13 February 2015

RE: Ausgrid's Revised Public Lighting Pricing Proposal 2014-19

Southern Sydney Regional Organisation of Councils

TABLE 1: Actual Unplanned Lighting Maintenance Tasks Reported by Ausgrid 2009-14

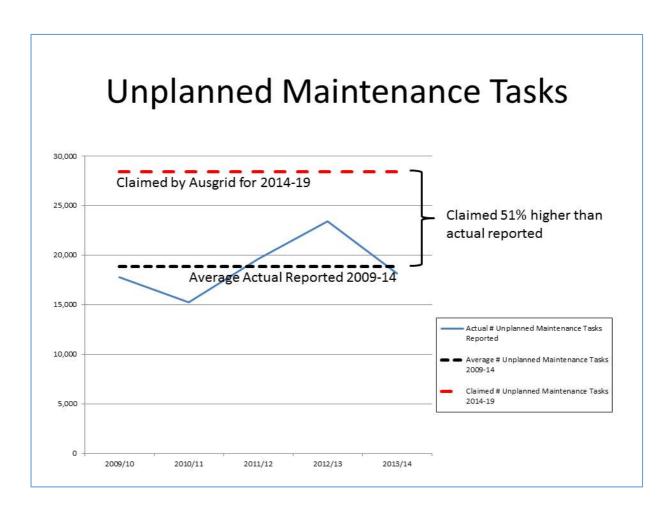
As per Table 1 below and the accompanying figure, total average annual unplanned maintenance tasks reported by Ausgrid from 2009- 14 in its annual reports were 18,837 per year. In contrast, Ausgrid's calculated number of unplanned maintenance tasks for 2014-19 is 28,463 or 51% higher than the average reported for the previous regulatory period. Ausgrid's claimed failure rates are so substantially in excess of reported data that Ausgrid's predicted failure rates should be wholly rejected by the AER.

Year	Reported # Unplanned Maintenance Tasks / Yr	Source
2009/10	17,764	EnergyAustralia Annual Report 2009/10 p20 ⁴
2010/11	15,251	Ausgrid Annual Report 2010/11 p20 ⁵
2011/12	19,613	Ausgrid Annual Report 2011/12 p13 ⁶
2012/13	23,404	Ausgrid Annual Report 2012/13 p16 ⁷
2013/14	18,154	Ausgrid Annual Report 13/14 p14 ⁸
Average Yearly Unplanned Maintenance Tasks (2009-2014)	18,837	Exceed Ausgrid's predicted rate of 28,463 unplanned maintenance tasks per year for 2014-19 by 51% compared to average over last regulatory period
